World Forum for Harmonization of Vehicle Regulations

Working Party on Passive Safety

Regulation No. 14 (Safety-belt anchorages)**Proposal for Supplement 3 to the 07 series of amendments****Submitted by the experts from Belgium and Germany***

Figure 1b

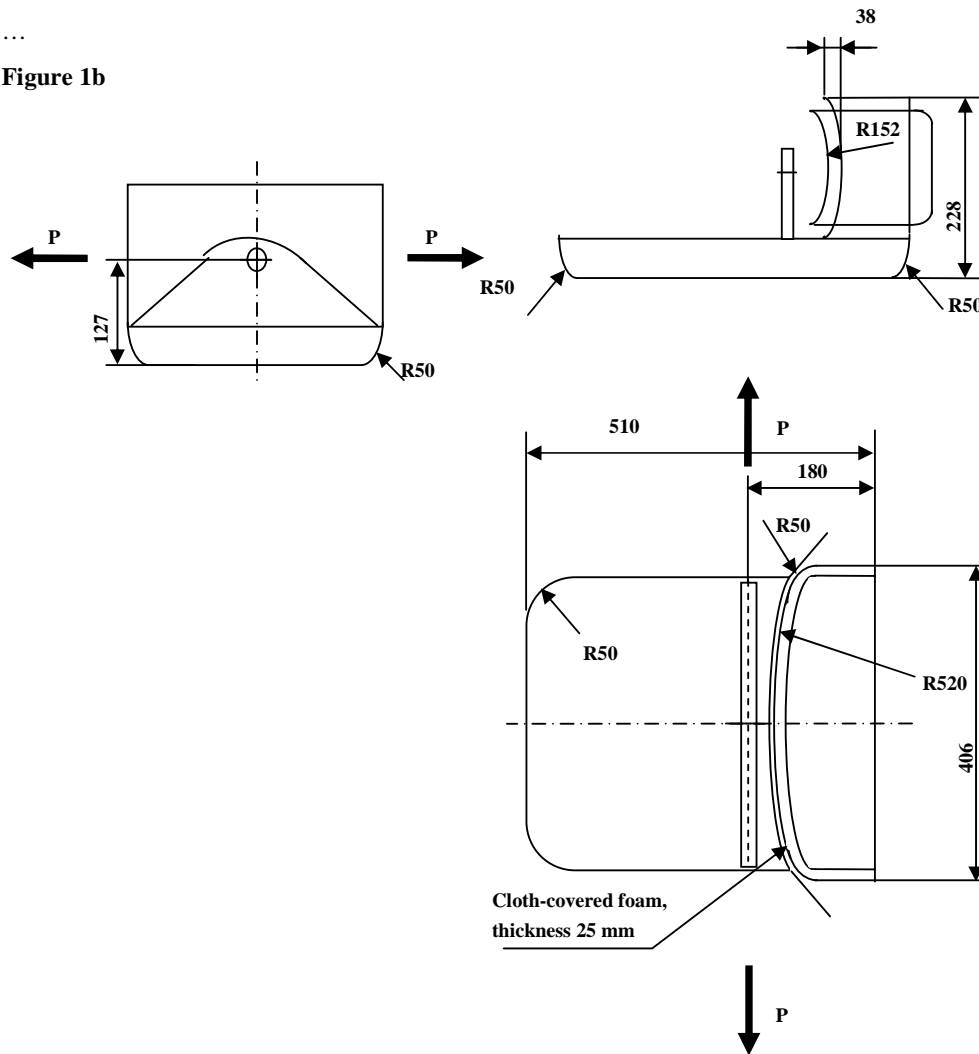
6.4.7.3. Traction device adapted for the test of side-facing seats is shown in Annex 5, figure 1b.

Annex 5, insert a new figure 1b, to read:
